STAFF REPORT
COMMUNITY DEVELOPMENT DEPARTMENT

HEARING DATE: 5/11/2021
TO: Mayor & City Council
FROM: Alan Tiefenbach, Associate Planner
208-489-0573
SUBJECT: FP-2021-0028
Cache Creek Final Plat
LOCATION: The site is located at 1560 W. Victory Rd and 2955 S. Locust Grove Rd, in the SE ¼ of Section 19, Township 3 N., Range 1E.

Final plat consisting of 41 buildable lots and 4 common lots on 13.99 of land in the R-4 zoning district, developing in a single phase.

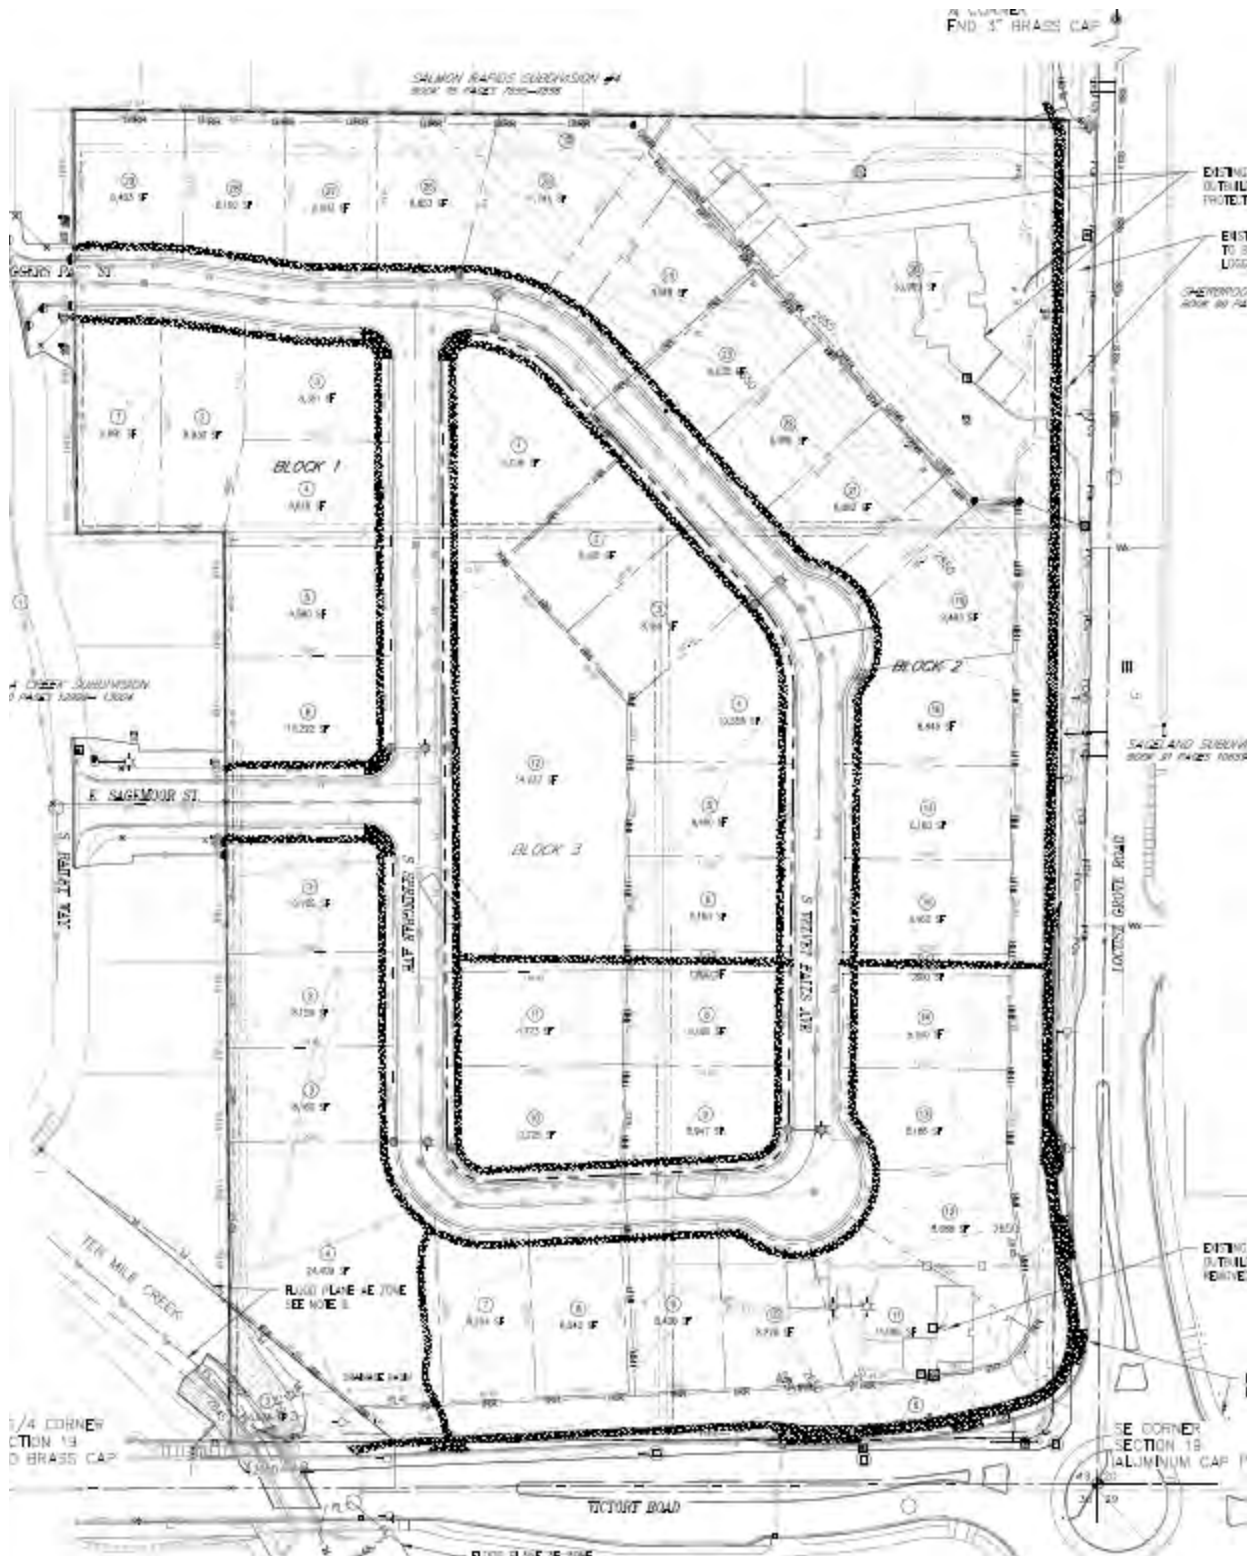
The existing accessory buildings shown in Lot 20, Block 2 do not appear to meet the minimum 15' rear setbacks as required in the R-4 zone district. The applicant understands as a condition of approval, the plat must be adjusted to ensure the structures maintain the proper setback or the structures shall be removed.

5. Prior to signature on the final plat, the applicant shall relocate all existing structures in Lot 20, Block 2 to meet the required setbacks for the R-4 Zone or shall remove the structures.

B. Final Plat (date: 4/29/2021)

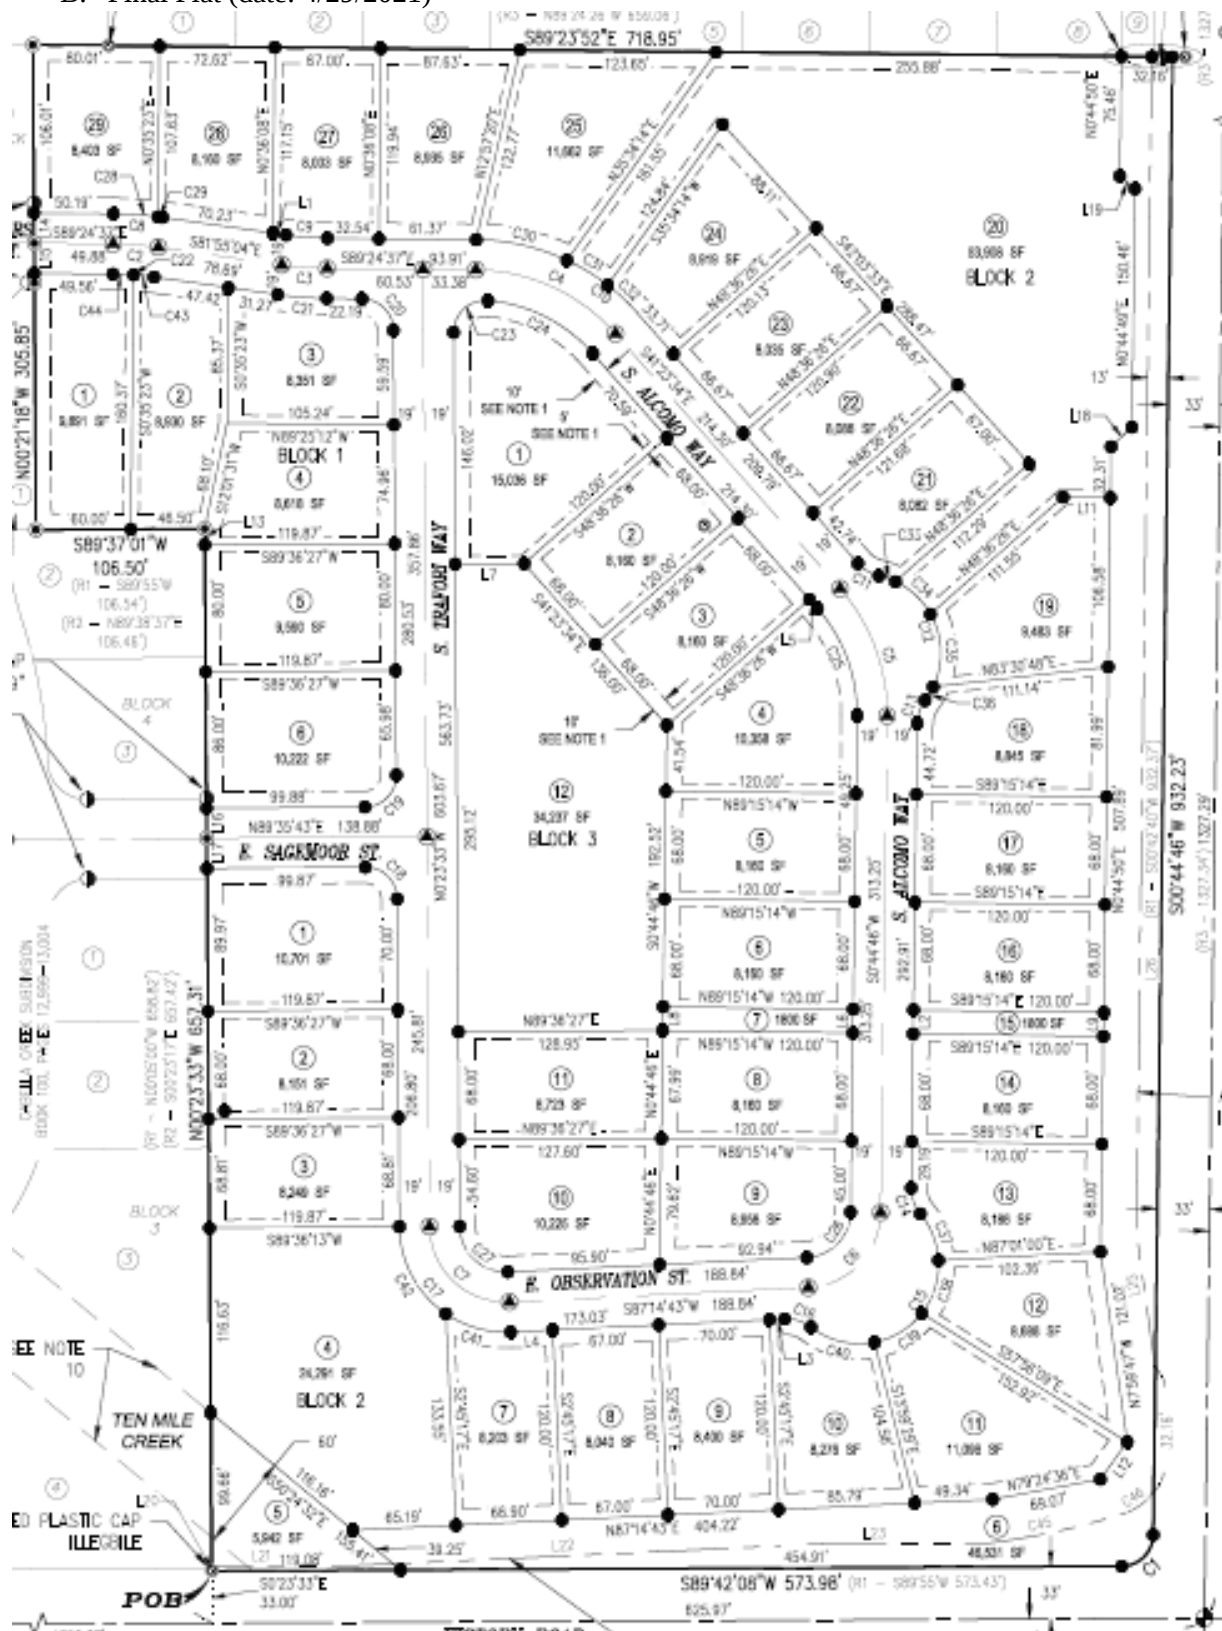
6. Prior to City Engineer signature on the final plat, the final plat prepared NV5, stamped by Robert Gromatzky, dated: 04/29/2021, included in Section V.B shall be revised as follows:

- a. Note 8, add Instrument Number.
 - b. Note 9, add Instrument Number.
7. The landscape plan prepared by Breckon Landscaping on February 10, 2021 is approved as submitted.
